REQUEST FOR INFORMATION	DATE: March 20, 2017	NO.: RFI-490
--------------------------------	-----------------------------	---------------------

Project Name:	15051-Webster University Interdisciplinary Science Building	Project No.: 15051
---------------	---	--------------------

Subject: Notching structural steel for shades

ROOM 317
VIEW FROM
WEST

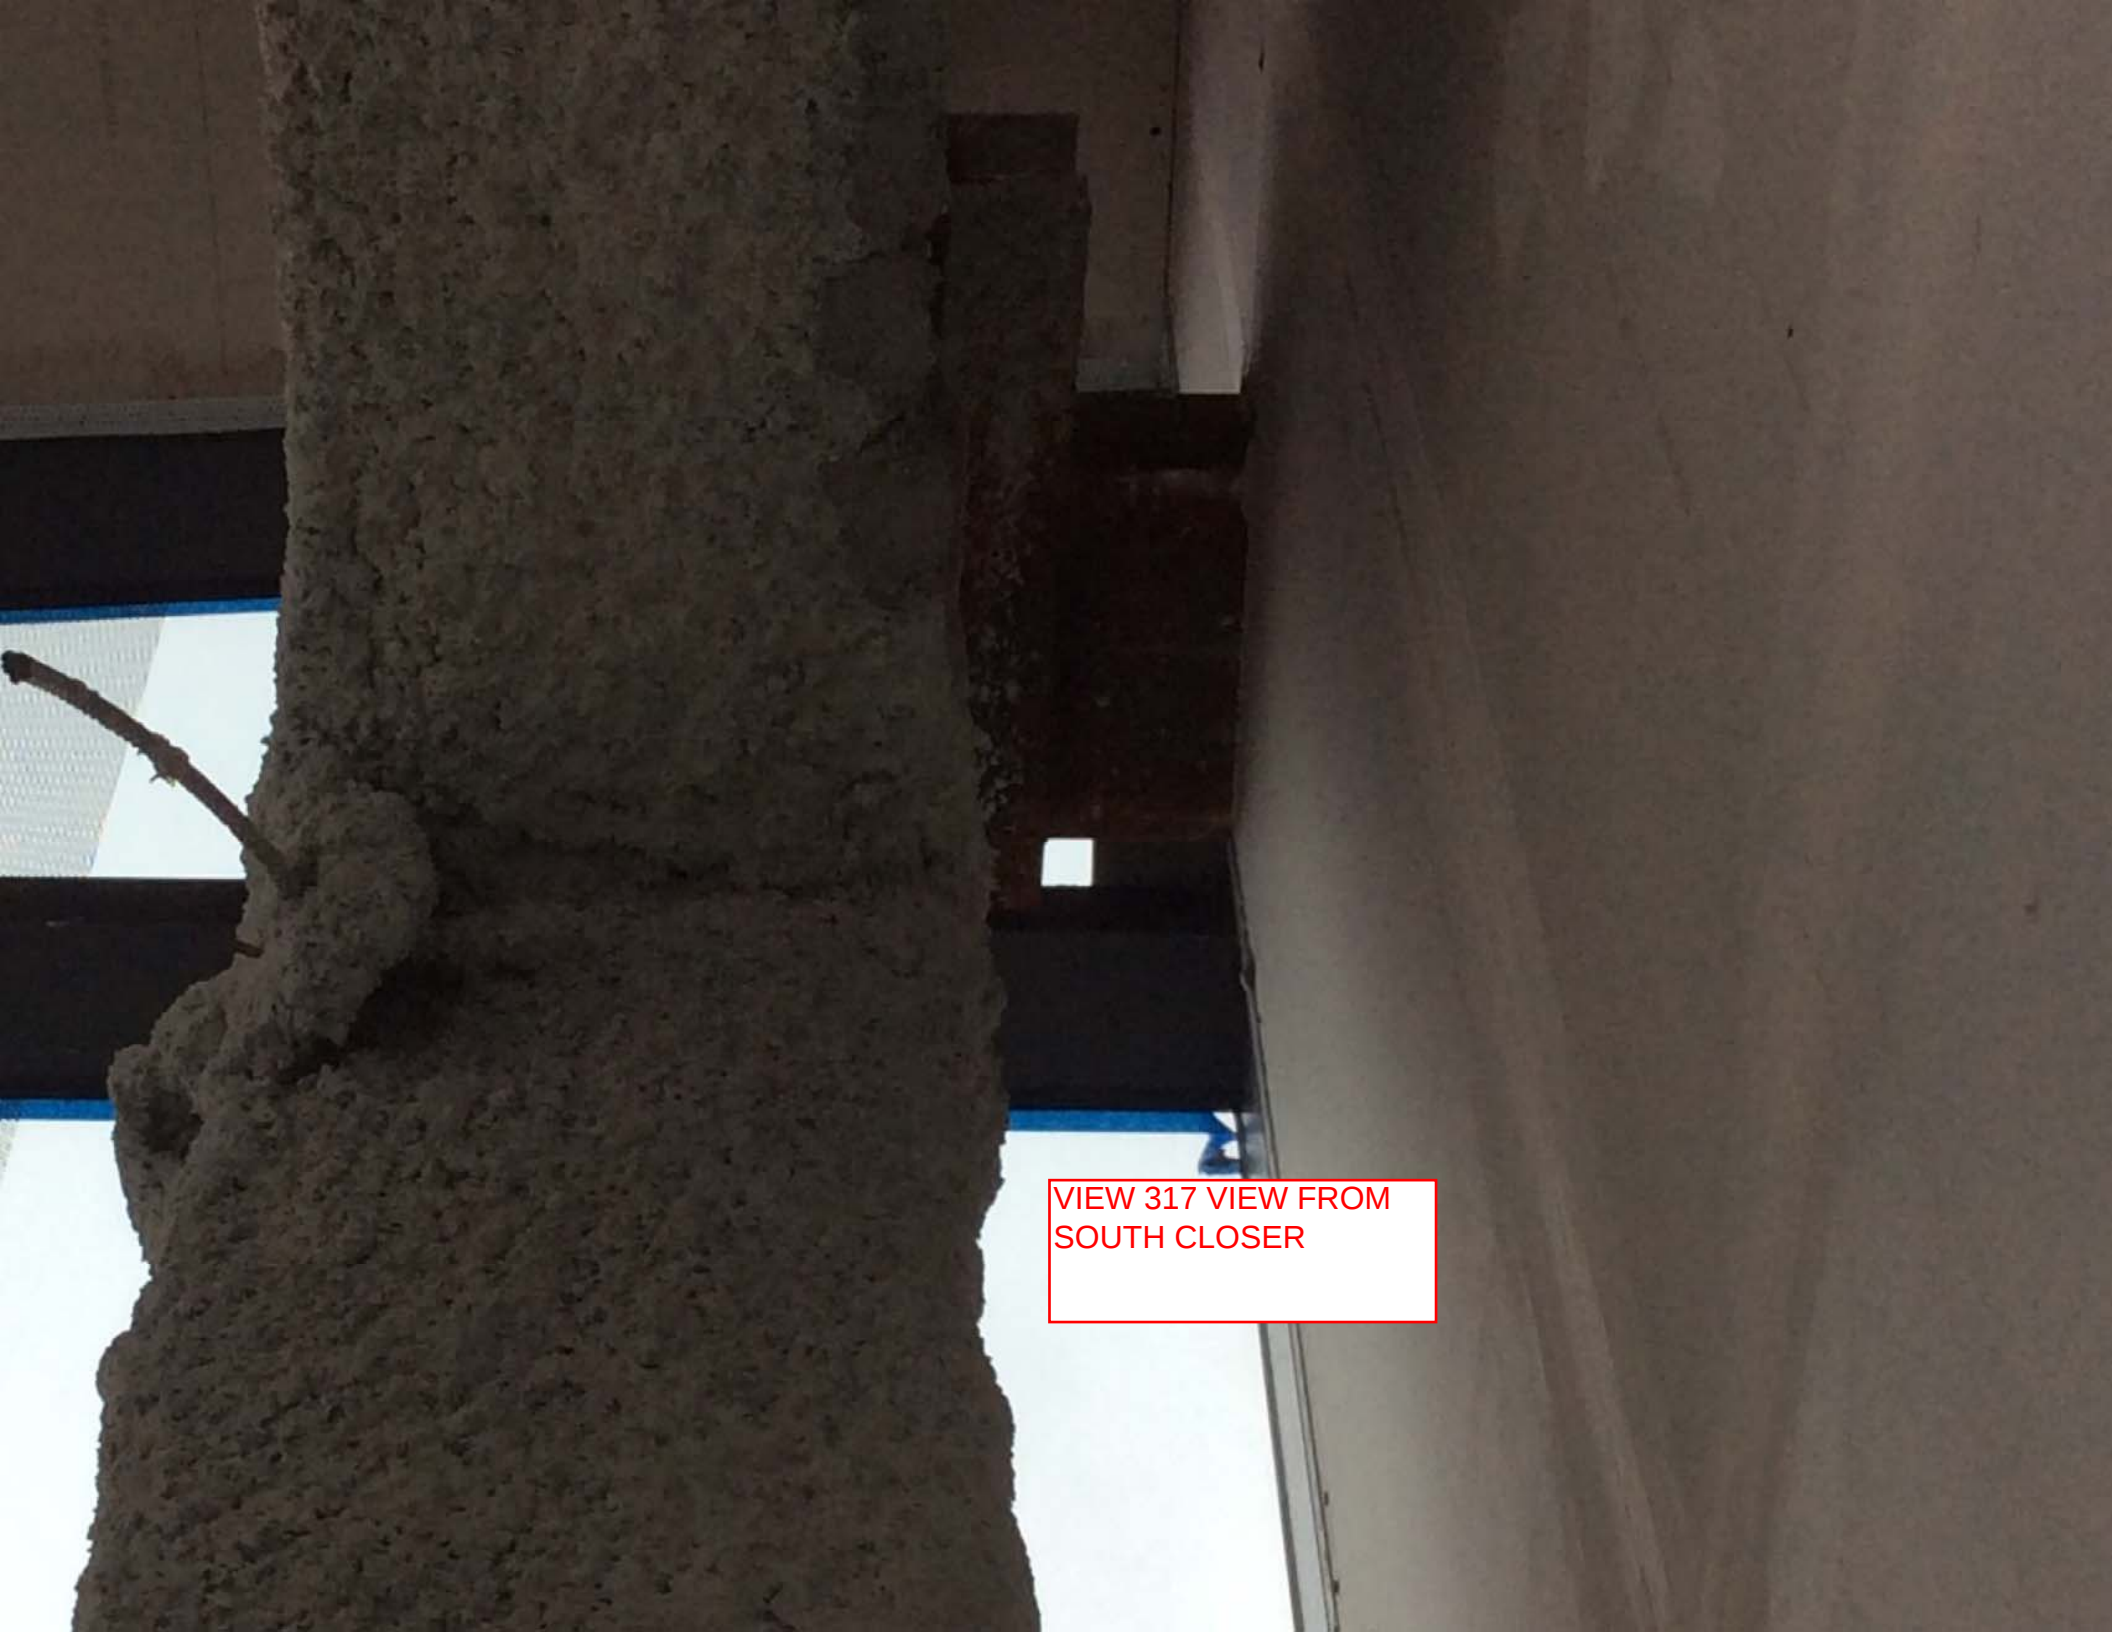
Per Paric and Cannon's field walk we have proposed to notch the structural steel flanges in room 317 and 356 to allow the shades to pass between the steel and the curtainwall. Please advise if this will be acceptable.

CAN WE NOTCH
THIS FLANGE TO
ALLOW THE
SHADE TO PASS?

The conflicting item is an angle which is part of the horizontal HSS connection.
The vertical leg may be coped as required for the shade. DO NOT cut the horizontal leg or get into the weld of the HSS to the angle.

ROOM
356 VIEW
FROM
WEST

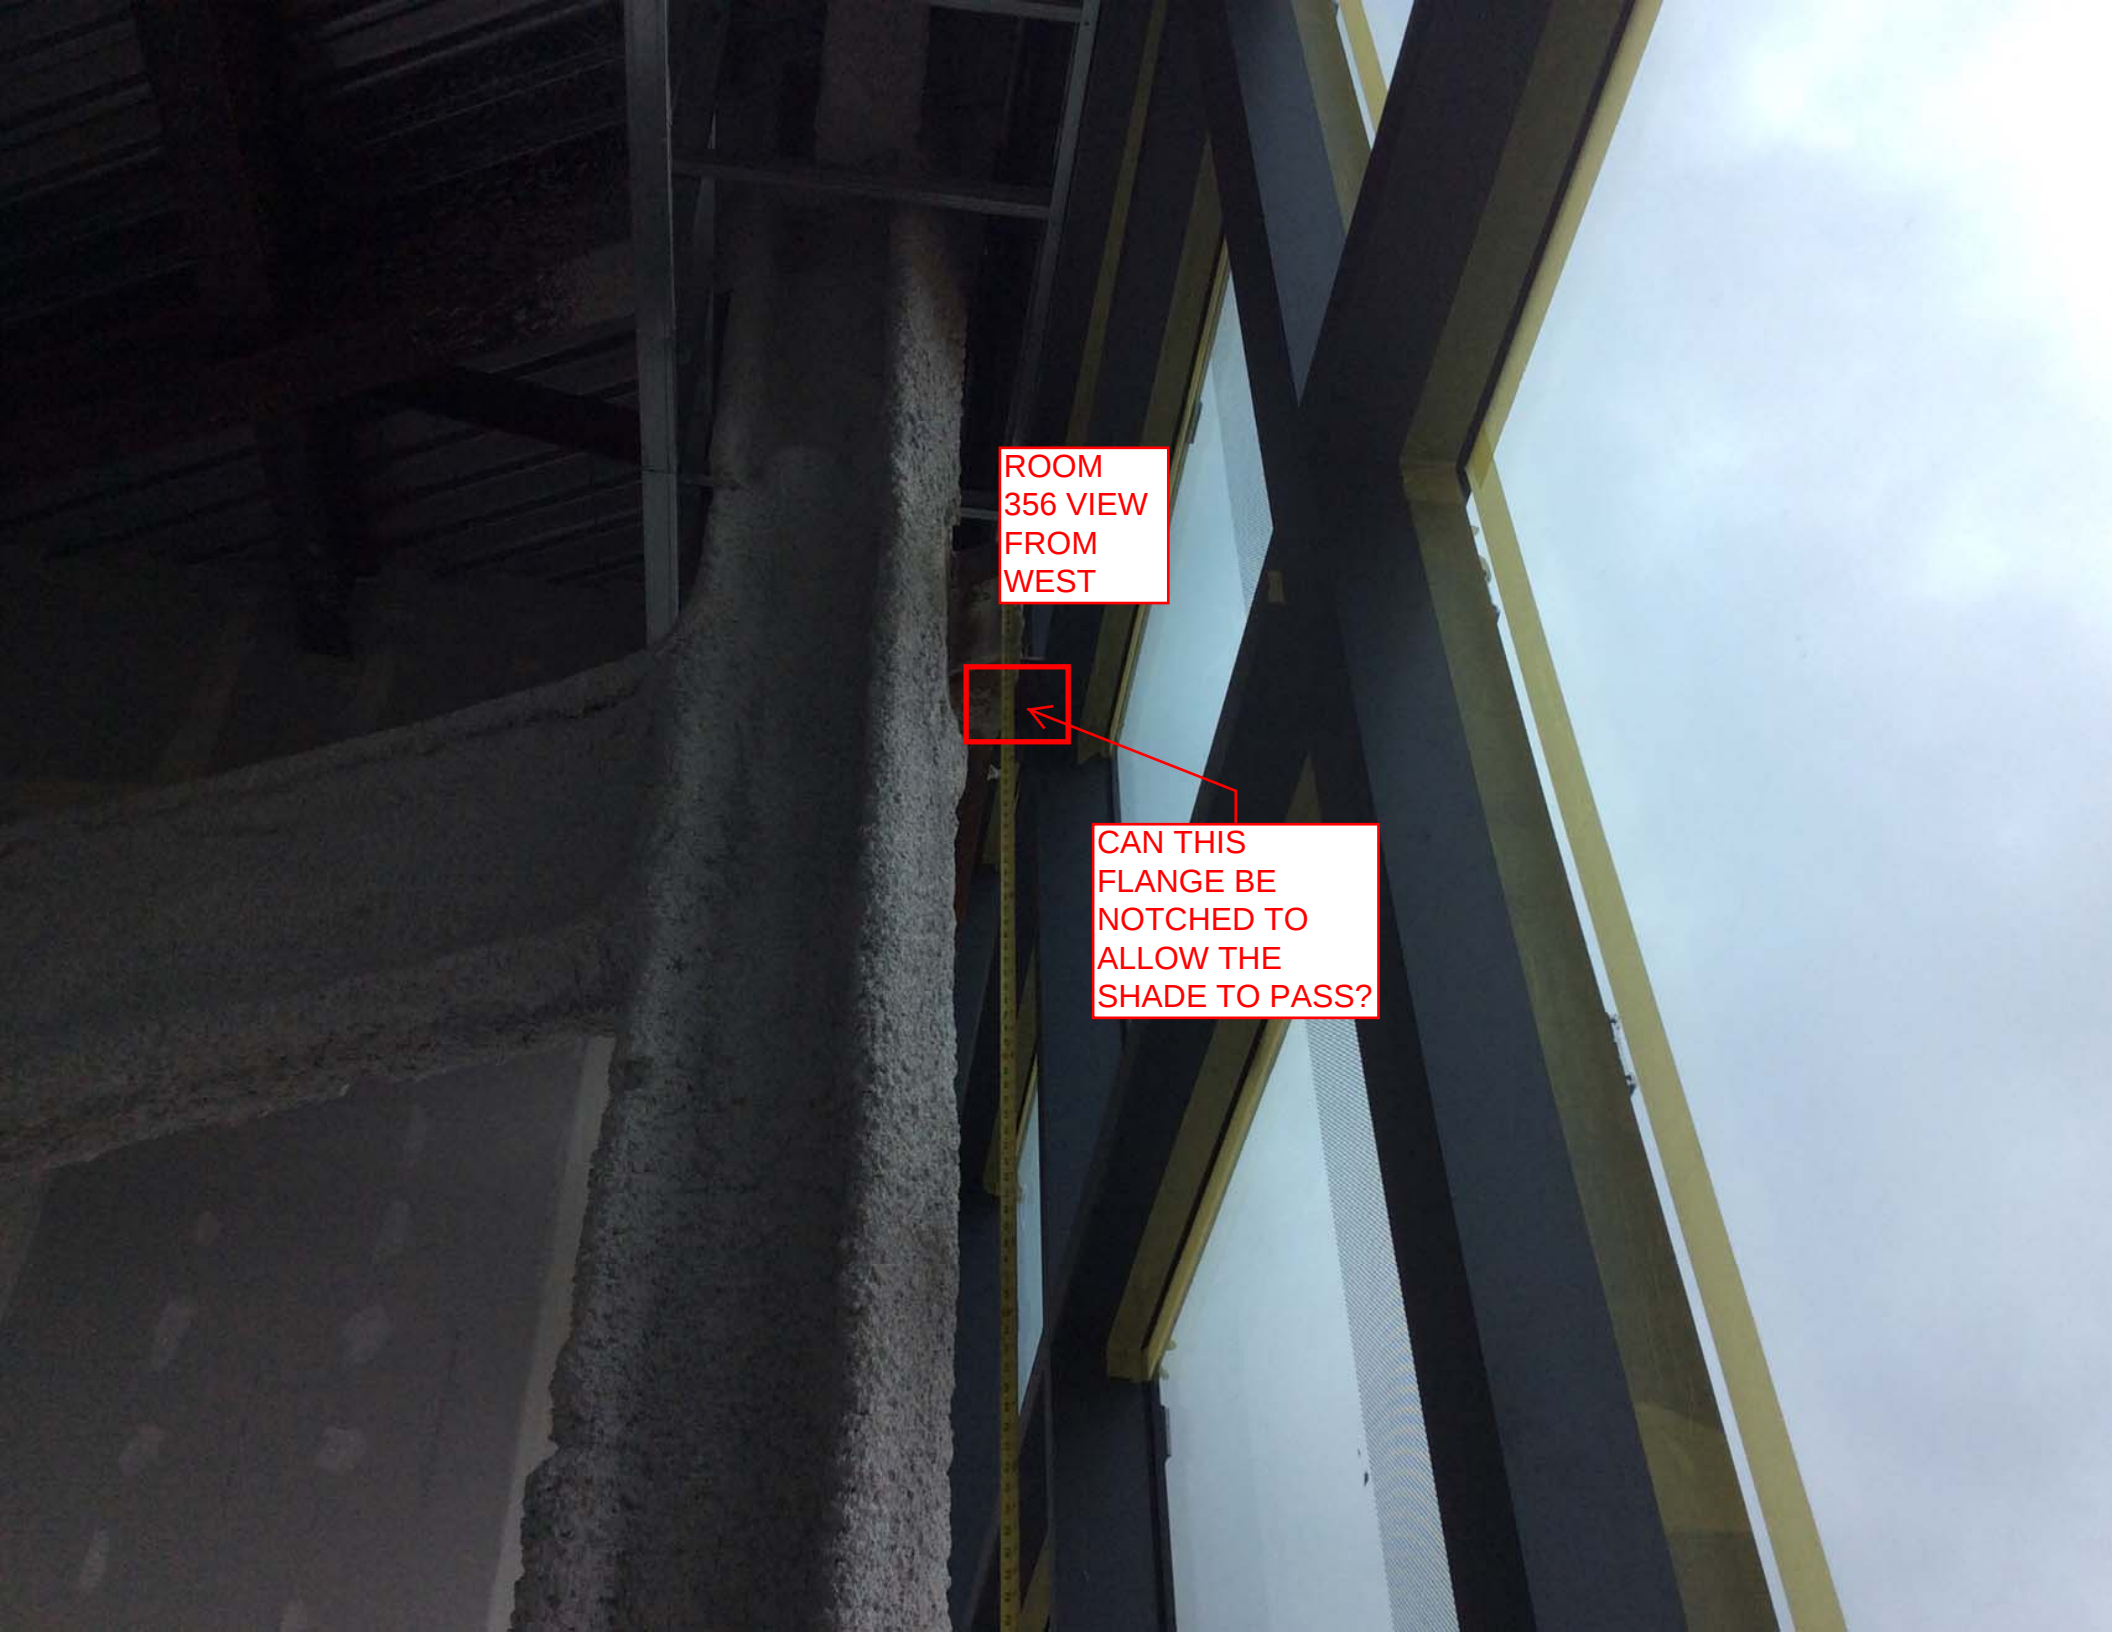
CAN THIS
FLANGE BE
NOTCHED TO
ALLOW THE
SHADE TO PASS?
